OGB PERMIT SUBMISSION: PERMIT REVISION TO #B1508708,
#B1608994, #B17071991 EXTEND PREVIOUSLY
APPROVED STEEL BALCONY W/ STONE PAVERS AT
EAST FACADE, AND ADD SUPPORT COLUMNS BELOW
WITH RETRACTABLE SCREENS AT GROUND FLOOR LEVEL.
USE PREVIOUSLY APPROVED CABLE RAILING DETAIL

PERMIT AMENDMENT
FOR
1231-35
31ST ST NW
WASHINGTON, DC 20007
LOT: 0046 SQUARE: 1209

AMENDED SCOPE OF WORK: EXTEND PREV. APPROVED
STEEL BALCONY ON EAST FACADE, ADD COLUMNS AND
RETRACTABLE SCREENS AROUND PERIMETER ON
GROUND FLOOR LEVEL

2 AMENDED BASEMENT FLOOR PLAN
SCALE: 3/16" = 1'-0"

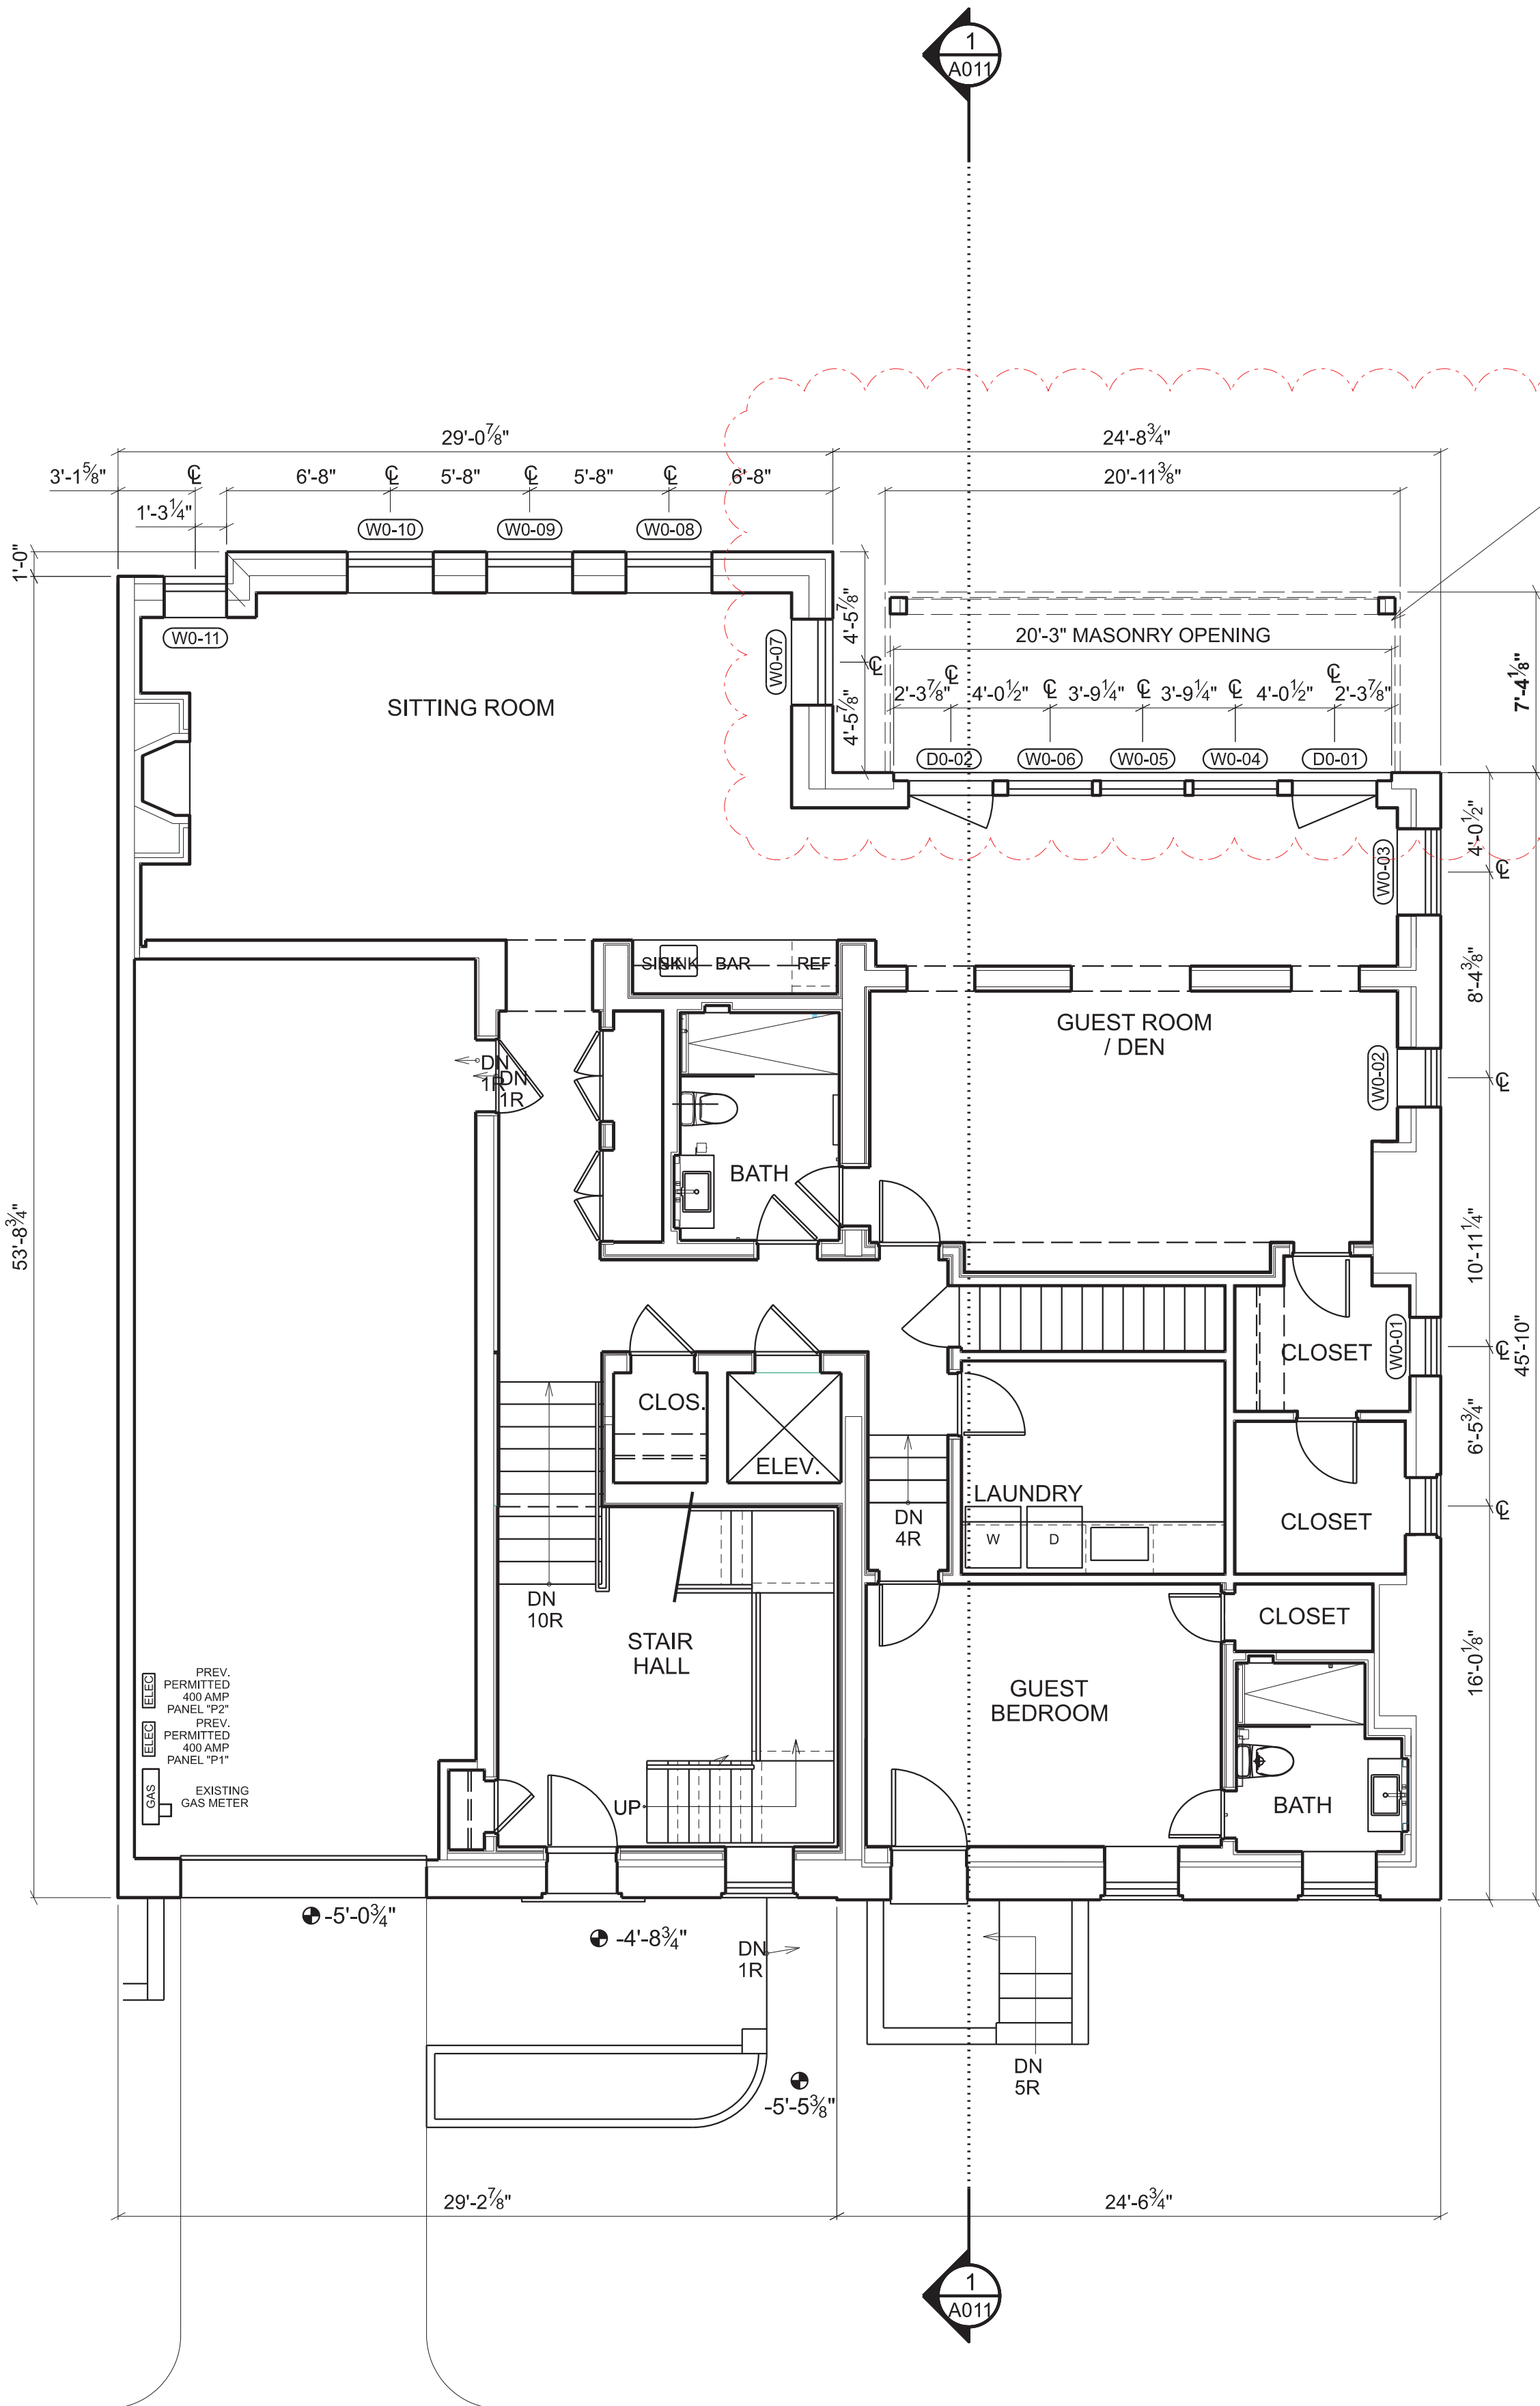
EXTEND PREV. APPROVED
STEEL BALCONY ABOVE
AND ADD RETRACTABLE
SCREENS AT PERIMETER

1 PROPOSED SECTION
SCALE: 1/4" = 1'-0"

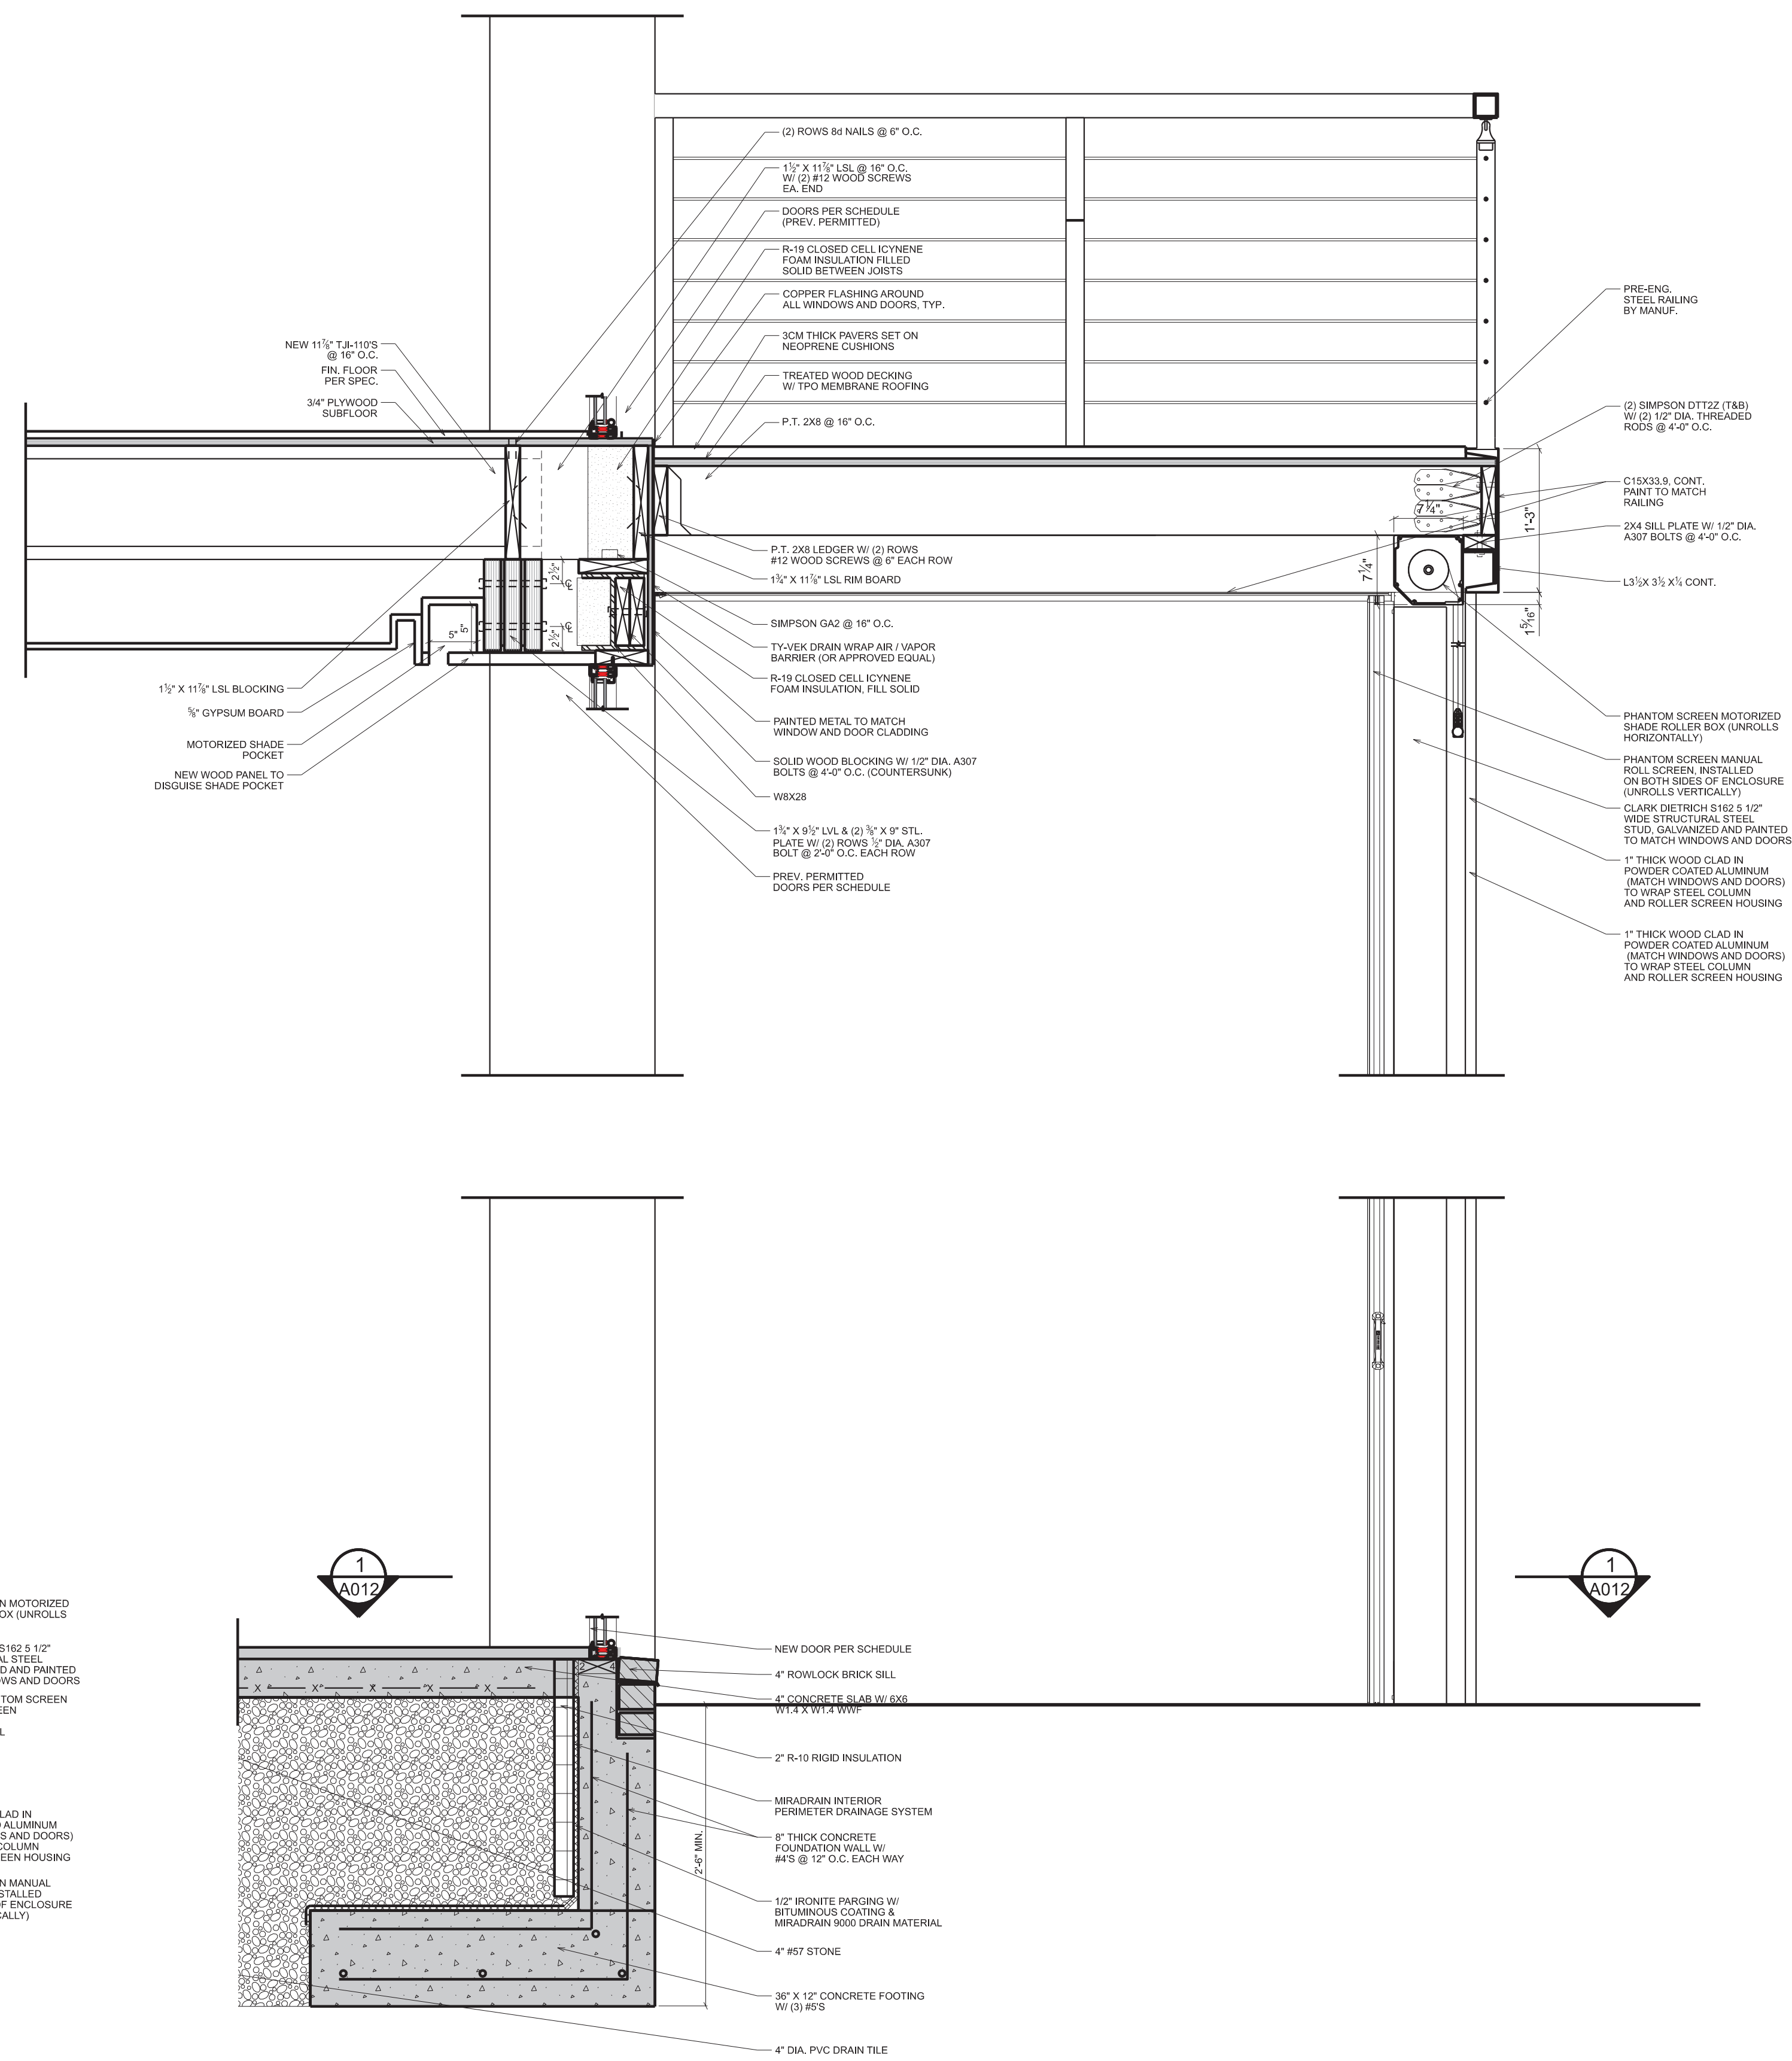
EXTEND PREV.
APPROVED
ALUMINUM AND
STEEL CABLE RAIL
SYSTEM ON NEW
STEEL BALCONY.
ADD NEW COLUMNS
BELOW WITH
RETRACTABLE
SCREENS
